That's It Fashion Ltd - Extension (previously Peak Apparels)

8 October 2024

2. Observations:

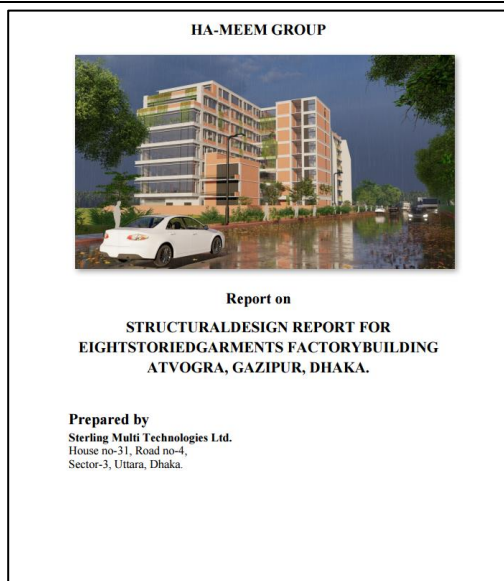
Observation-1: Inconsistencies in as-built drawing. (Production Building (Extension))

1. LL = 84 psf & no portion wall is allowed cantilevering in all zone except hatched portion [see S-55]																									
<u>Roof floor beam layout</u>	<u>Roof floor beams at the east side</u>

NO	ITEM	MAX. LOAD (psf)	DESCRIPTION	1	CUTTING SECTION	84	Typical Cutting Machine	2	TRAINING ROOM	84	Typical Floor plate	3	STAIR CASE	105	Typical Floor plate	4	PLANT	250	Typical Floor plate	5	STORAGE	125	Typical Floor plate	
NO	ITEM	MAX. LOAD (psf)	DESCRIPTION																						
1	CUTTING SECTION	84	Typical Cutting Machine																						
2	TRAINING ROOM	84	Typical Floor plate																						
3	STAIR CASE	105	Typical Floor plate																						
4	PLANT	250	Typical Floor plate																						
5	STORAGE	125	Typical Floor plate																						
<u>3rd-floor load plan-Cutting (84 psf)</u>	<u>3rd floor-store (125 psf)</u>																								
Description: During inspection, the roof floor beam layout at the East side cantilever zone did not match the drawing. Also, the cutting section (84 psf) was mentioned in the 3rd floor load plan but was found as storage (125 psf) on site. The building engineer is required to update the as-built drawing according to the as-built condition, revise the load plan as per BNBC requirements and check the design accordingly.

Observation-4: Signage of water ponding on the roof. (Production Building (Extension))

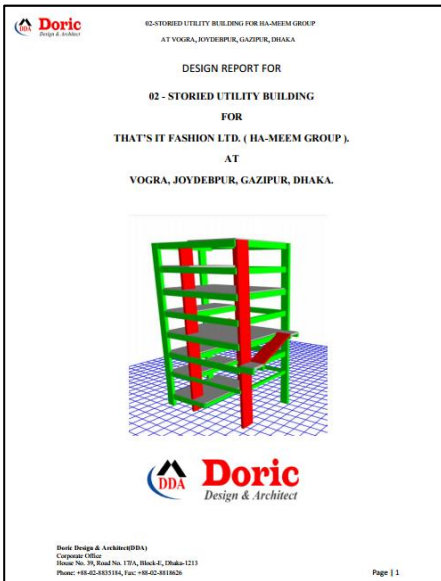
Description: During the inspection, signage of water ponding was found on the roof. The building engineer is required to improve the roof drainage system.
